YUCCA MOUNTAIN PROJECT

**A CONSENSUS PEER REVIEW OF PREDICTIONS OF SEEPAGE INTO
THE DRIFTS OF A PROPOSED REPOSITORY AT YUCCA MOUNTAIN**

September 28/99

Figure 4.1

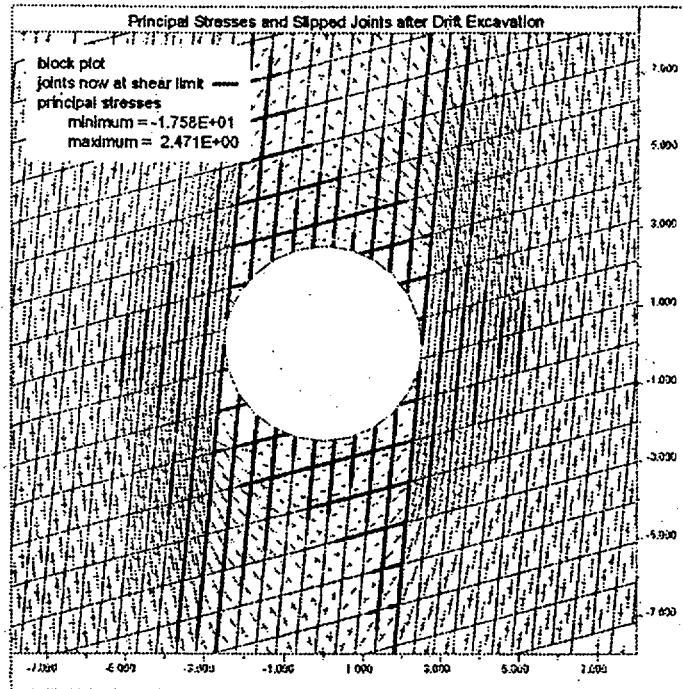
Figure 4.1 (from Fairhurst 1999) illustrates potential slip planes along subvertical fractures after excavation and before thermal heating. Figure 4.2 (from Chen 1999) illustrates a potential configuration of blocks around a drift after a seismic event but before heating. In either illustration it is not difficult to conceive how the capillary barrier to drift seepage surrounding the drift has been permanently affected. Repository heating tends to close fractures and reduce the impact of seismic events. These illustrations are included here to demonstrate that although modeling effort is underway by the YMP to assess roof stability for engineering a repository at Yucca Mountain, it appears none of the modeling has been directed at understanding the implications of geomechanical responses to predicting moisture seepage into the repository drifts.

Figure A.4.1

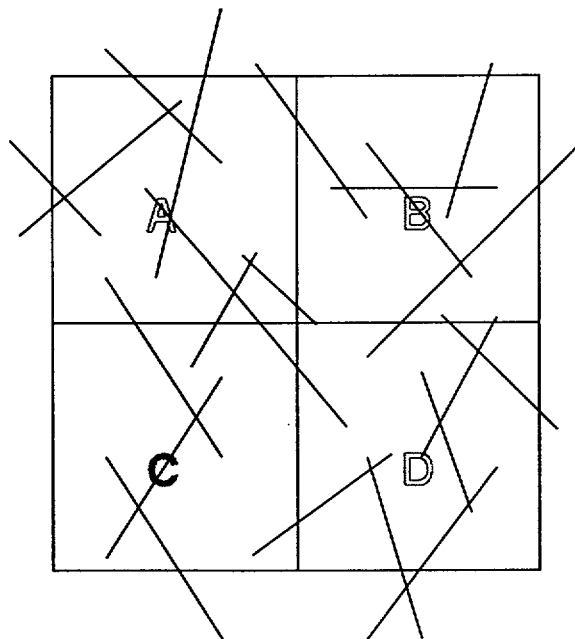
Figure A.4.1 shows a hypothetical fracture pattern and some 2D square elements. The goal of effective properties is to calculate values for flow parameters, such as permeability, for each grid cell that enables the grid cell to mimic the flow effects of the fracture network (and the rock matrix if the matrix is permeable). The diagram shows that all four squares have continuous fracture pathways from the bottom of the cell to the top. Likewise, cells A and B have continuous fracture paths from left to right. In order to correctly represent the permeability of each of these cells, all four would require some component of fracture permeability in the up-down direction, and cells A and B would require fracture permeability in the left-right direction. This would make it possible for moisture to flow from the top of the model to the bottom or from the left edge to the right.

Figure A.4.2

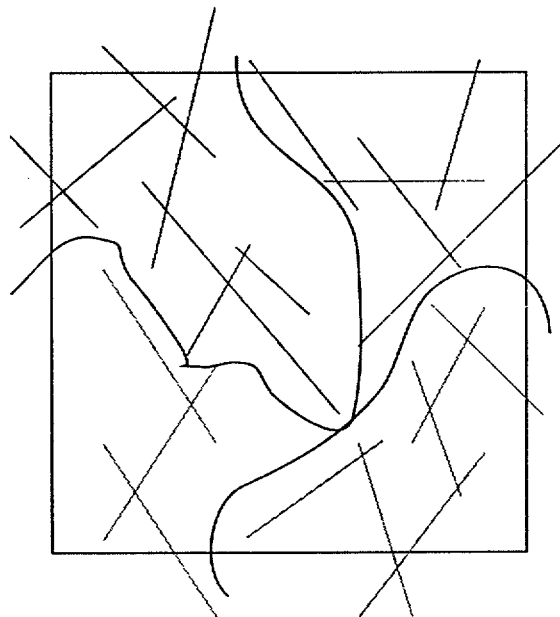
However, when moisture flow is considered on a larger scale, we find that this representation is not correct and could lead to erroneous results. Consider the same diagram, but now as a single larger grid cell (Figure A.4.2).

Figure A.4.2 shows that in fact there is no continuous fracture pathway connecting the top of the model to the bottom, or the left side of the model to the right. Rather, the fracture network is compartmentalized, as shown by the lines we have added to the diagram to separate the fractures into separate clusters. If moisture were introduced to the top of the model, it would not percolate via fracture pathways to the bottom of the model. However, an effective parameter calculation would suggest that continuous percolation would occur, when in fact it could not. Work at the Kamaishi mine in Japan has demonstrated that this type of fracture network compartmentalization occurs at the drift scale. Work in fractured oil reservoirs indicates that compartmentalization of the connectivity of fracture networks is common at larger scales as well.

Figure A.4.3

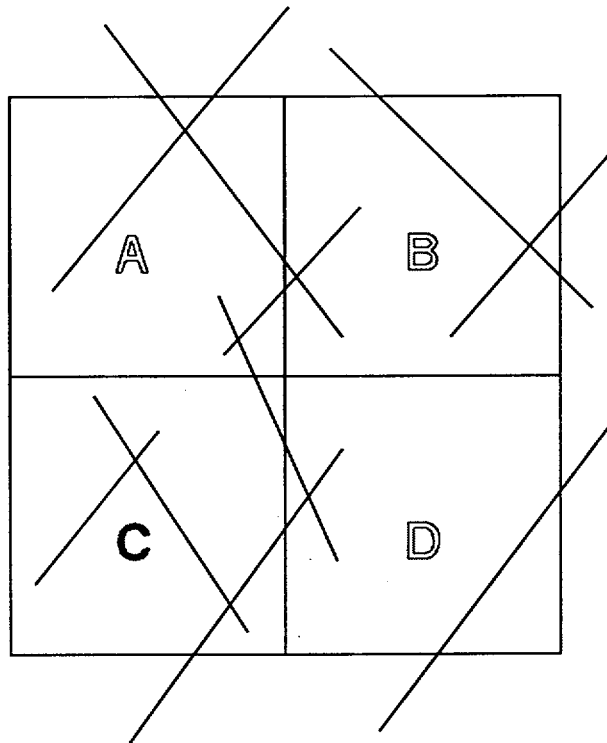
The opposite situation can also occur. Consider Figure A.4.3. Not one of the four grid cells has a continuous pathway from top to bottom or from left to right that is completely contained within the grid cell. This would imply that the effective fracture network permeability in each grid cell is 0.0. However, there are continuous fracture pathways from top to bottom at a larger scale. In this instance, there would be percolation from the top of the model to the bottom through the fracture network, whereas an effective parameter calculation would indicate that there could be none.

Another interesting challenge in calculating effective parameter values for describing moisture percolation through fracture networks is shown in grid cell D of this example in Figure A.4.3.

Presumably, water could be introduced to the fracture on the right side of D and it would flow out the fracture at the bottom of D. To represent this as a tensor, one would have to have a non-zero value for the off-diagonal component, or K_{xy} . However, there is no component for K_{xx} or K_{yy} : they are 0.0. Moreover, as shown by studies of the electrical resistance of line patterns (La Pointe and Hudson 1985), the principal directions of resistance (or conductivity) are not necessarily orthogonal, nor are they limited to two directions even in 2D line patterns. Both these situations are very difficult to capture through a symmetric permeability tensor that underlies the effective permeability parameter approach.
